Remarks

Amendments to the Drawings

FIG. 4(A)

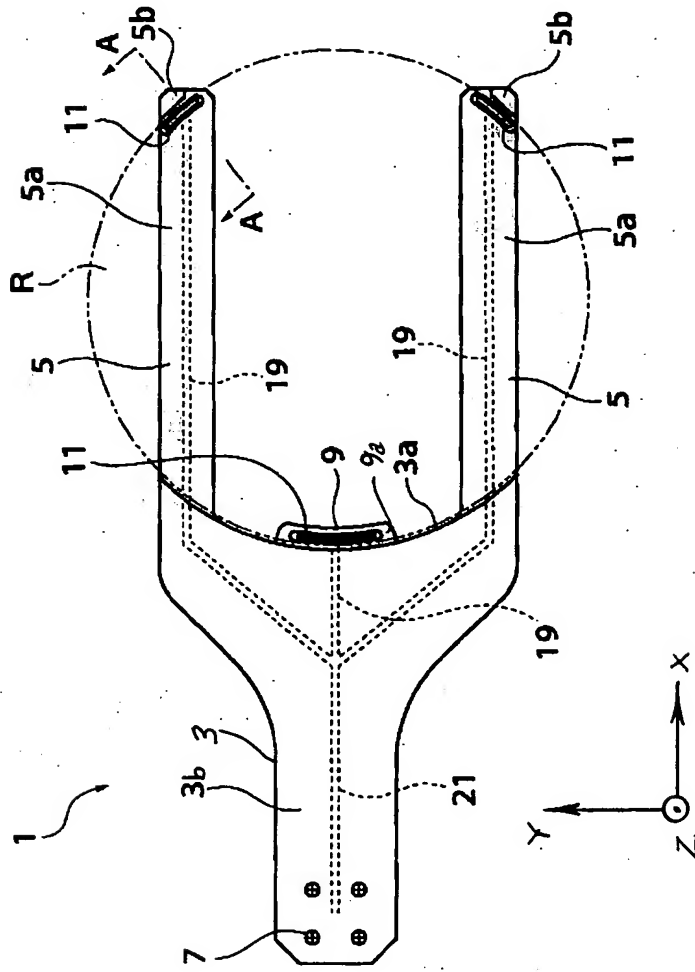
The drawings are objected to for allegedly failing to depict vacuum apertures situated equi-distantly and equi-angularly with respect to each other. In response, FIG. 4(A) and the paragraph beginning on page 11, line 11 have been amended. No new matter is submitted.

Enclosed herewith is a revised sheet containing FIGS. 4(A)-4(C), in which FIG. 4(A) is amended as discussed herein. Also attached is a "markup" sheet highlighting the changes to FIG. 4(A).
